PAUL OVERTON ARCHITECTS

Client		
Mr. J. McCarthy		
Project		
2 Morlais Buildings High Street Merthyr Tydfil CF47 8UL		
Drawing Title		
Existing and proposed side elevation to rear yard		
CAD ref	Drawn	
	PRO	
Date	Scale	
April 2020	1:50	
Project No.	Drawing No.	Revision
9038	03	A

PROPOSED ELEVATION TO GROUND FLOOR REAR YARD

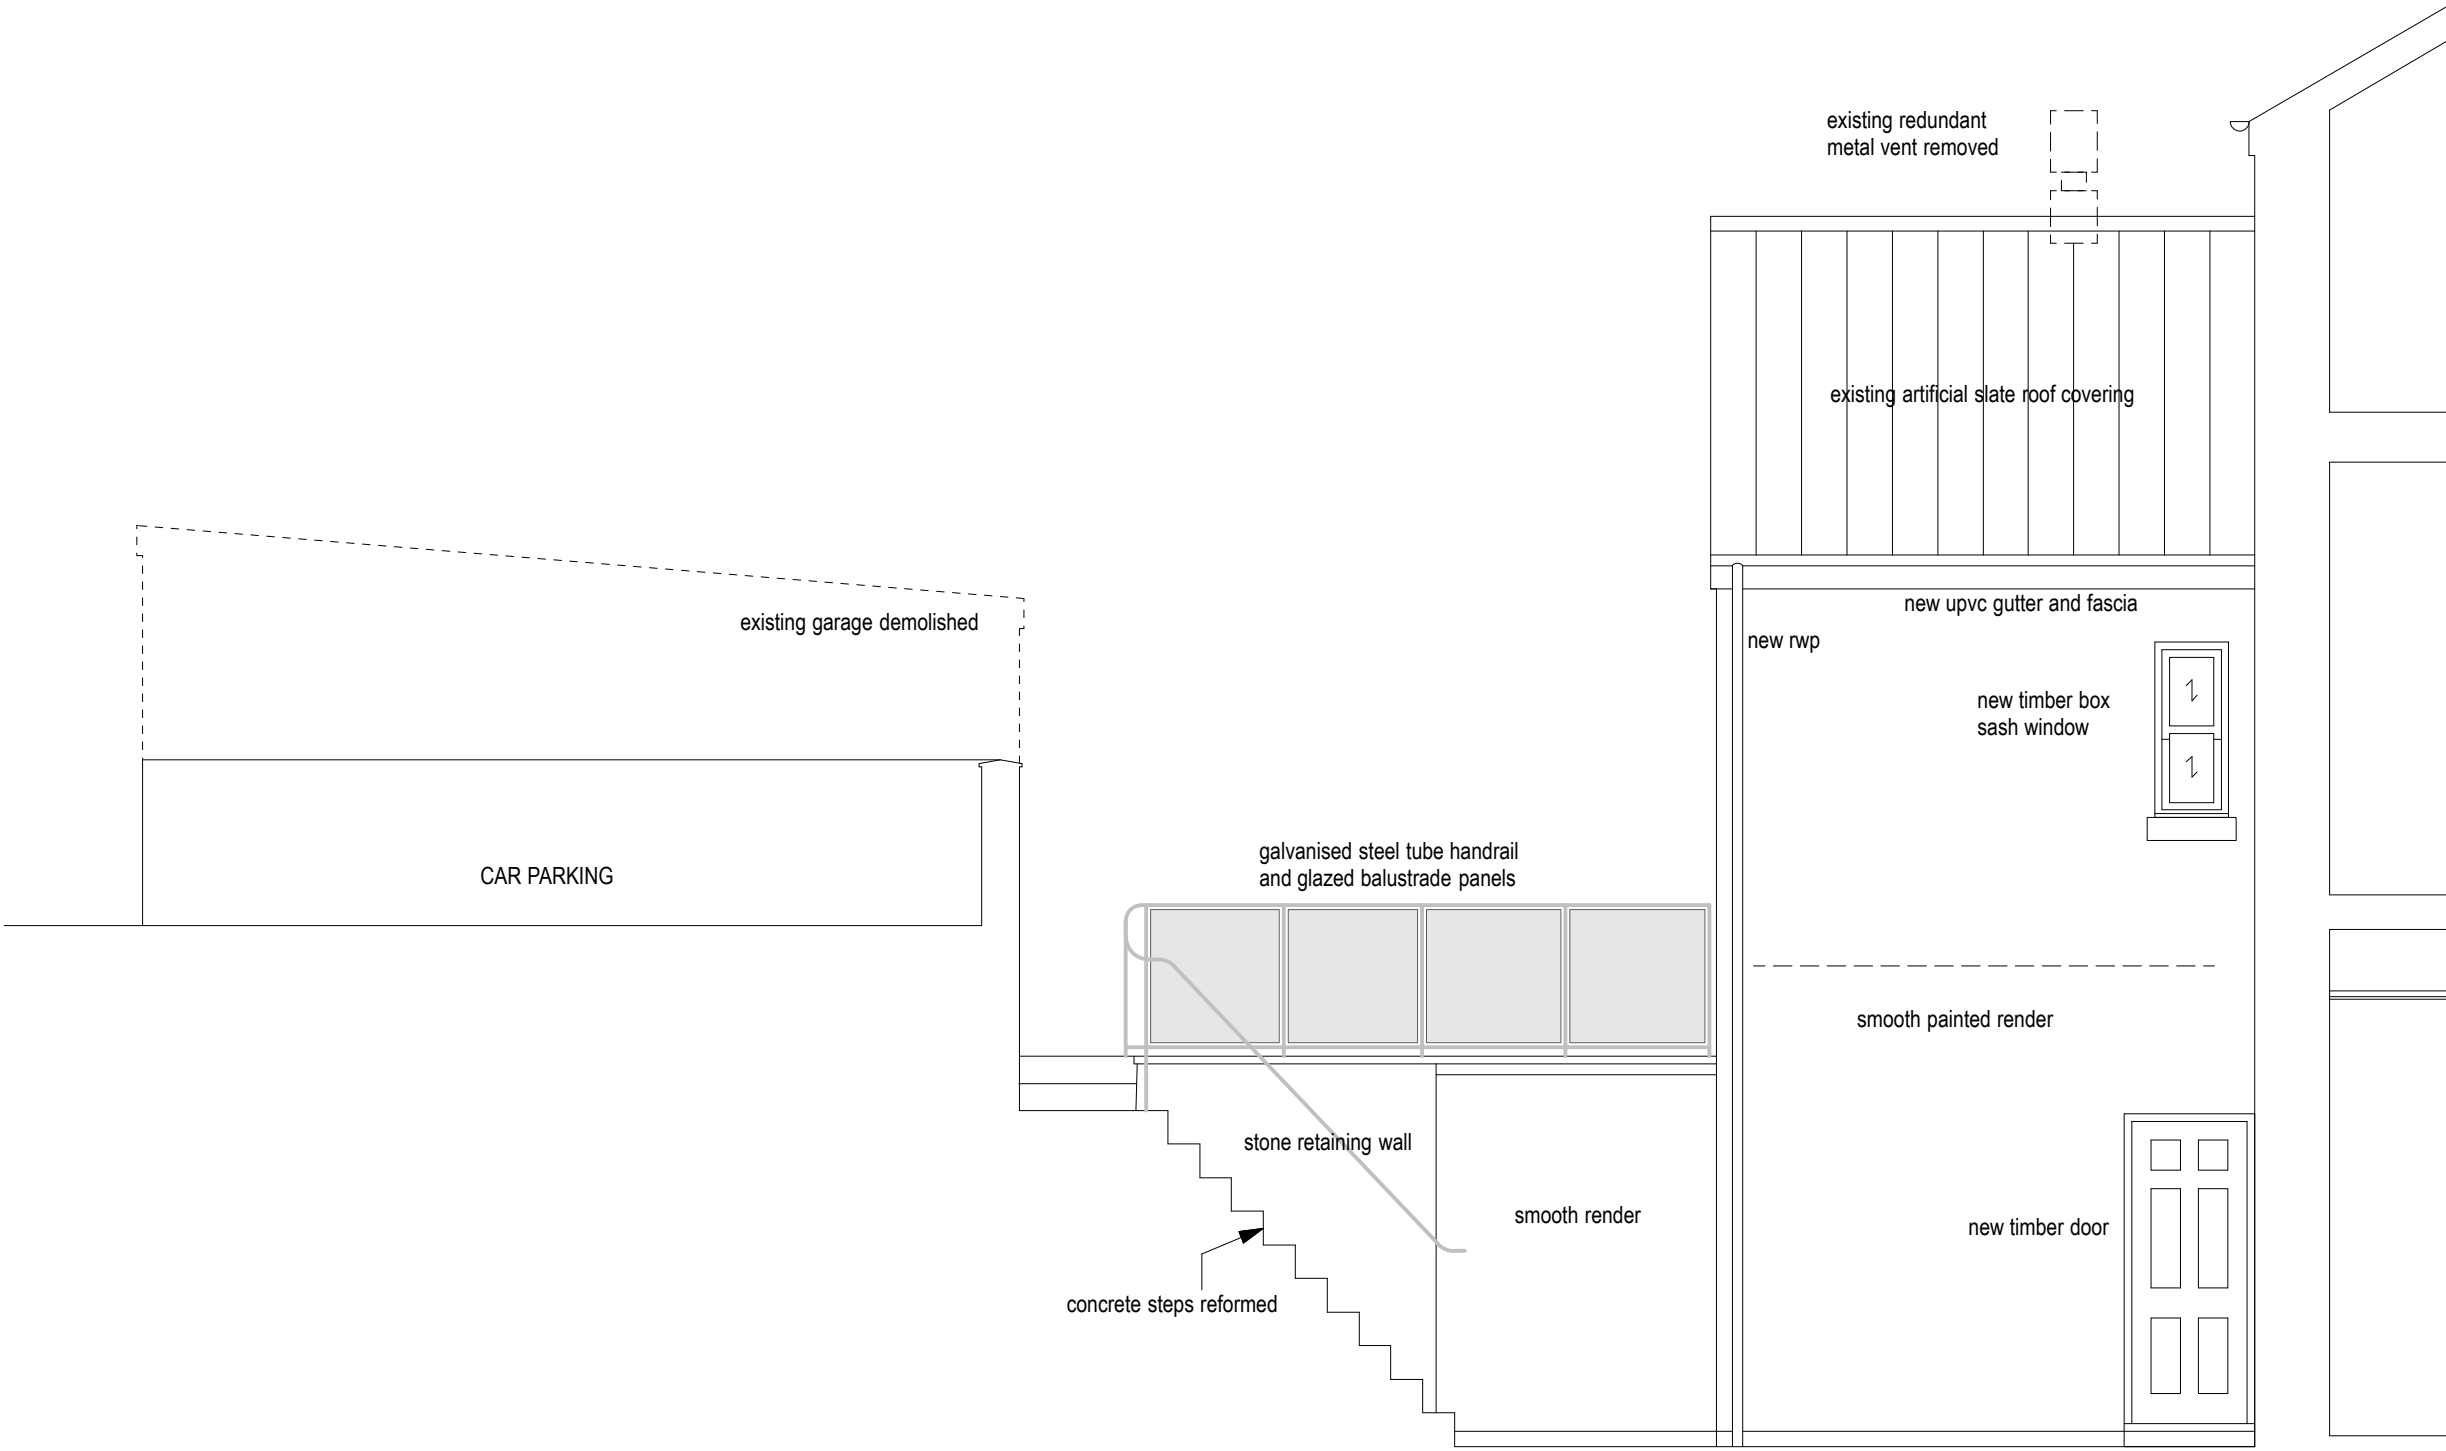
revision A - 01/09/20 - proposed rear extension window revised to timber box sash. Proposed rear elevation door revised to timber panel door.
